To: Manager – Planning & Regulations
From: John O'Connor – Utilities Engineer
File: WAS 16/11
Date: 1 May 2008
Subject: Plan Change 13 – Twizel Water Supply Protection Area

TWIZEL WATER SUPPLY PROTECTION AREA

TITLE					
MACKENZIE DISTRICT COUNCIL TWIZEL WATER SUPPLY					
WATER SUPPLY PROTECTION AREAS PROPOSED REVISIONS					
STATUS		FOR COMMENT		FILE	
				3CW494.00	
SCALE	PLOT DATE	FEATURE IDENTIFIER	CODE	SHEET	REVISION
AS SHOWN	24/08/07 @ 13:49			WPZ	RO

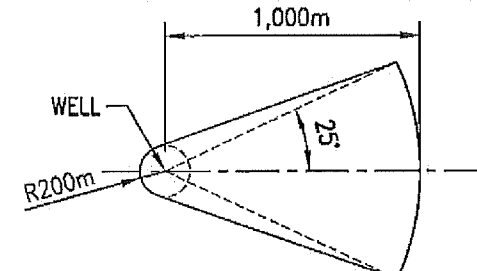
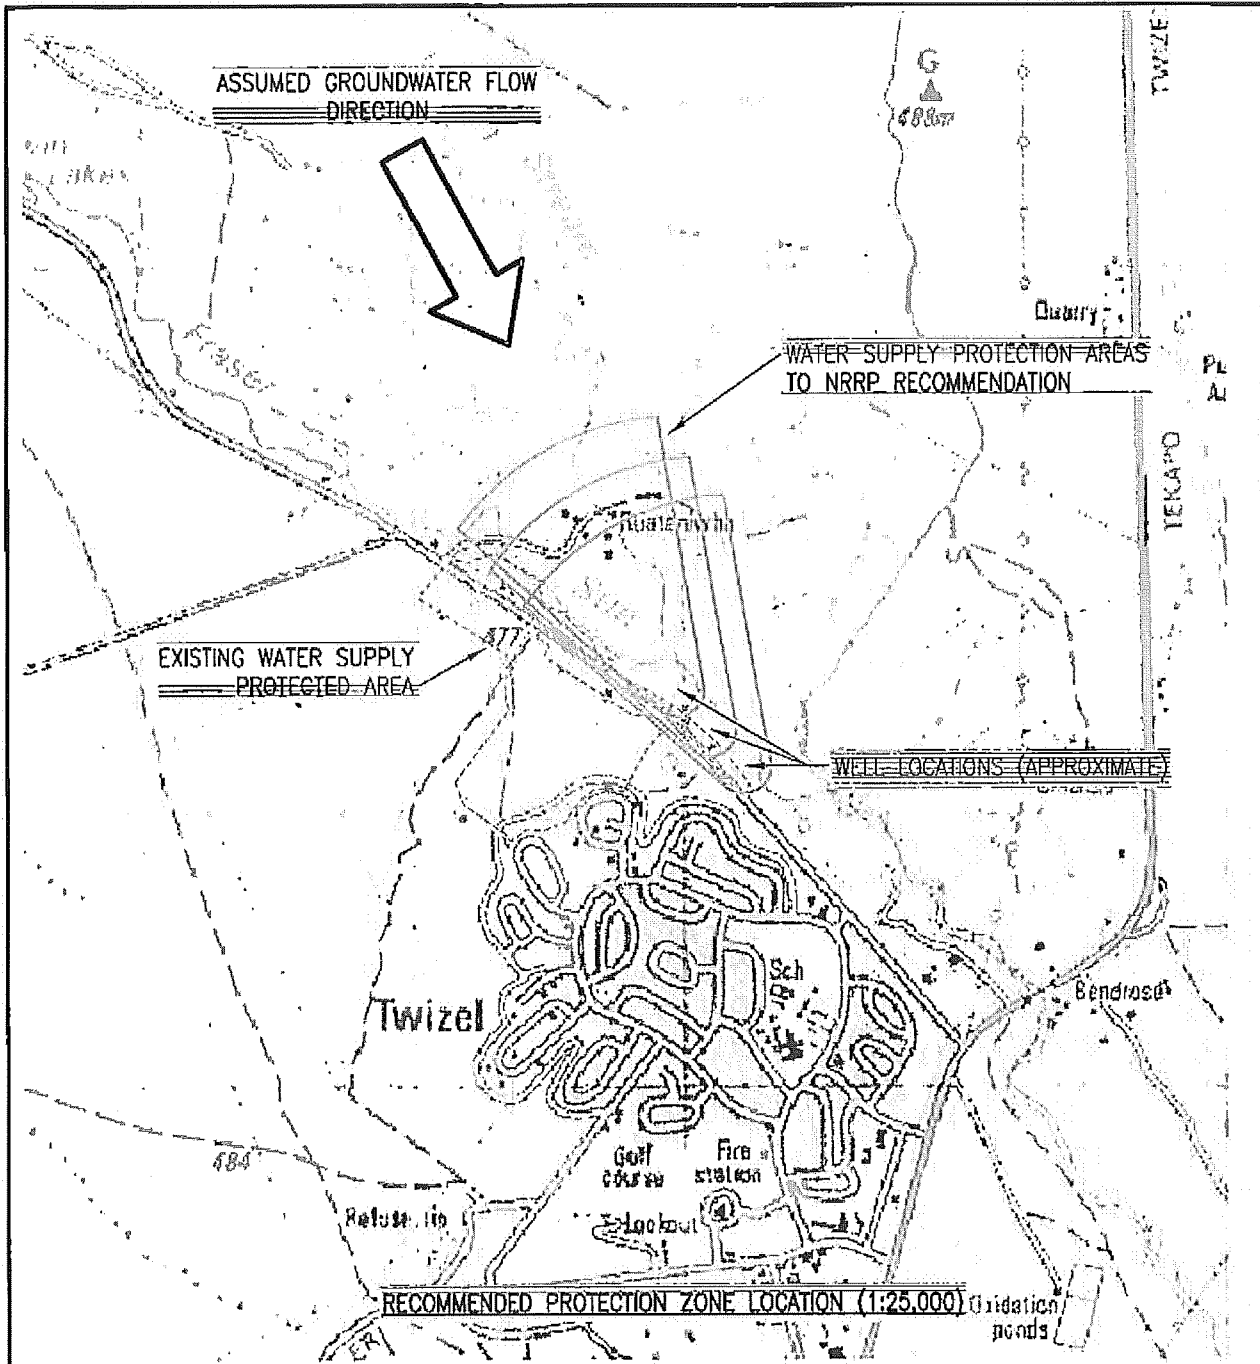
We have attached a drawing showing the extent of the existing protection area, and proposed areas using the NRRP method to all the wells. We have done this as the spacing of the wells means that there are unprotected areas if the NRRP co-ordinate is used. However, this does mean that the District Plan and NRRP would not be exactly the same. You will note that there is a significant difference between the existing and proposed area, and we believe that this justifies your concerns.

The proposed protection area shown are based on an assumed groundwater flow direction (which we expect would generally follow the river direction), and approximate location of the bores. These assumptions should be verified as correct prior to including in the District Plan if possible with accurate survey and measuring of piezometric heads (if facility for this is available).

We recommend that the District Plan is amended in accordance with this letter and drawing, subject to confirming the assumptions above. Ideally, the NRRP should be amended to provide protection
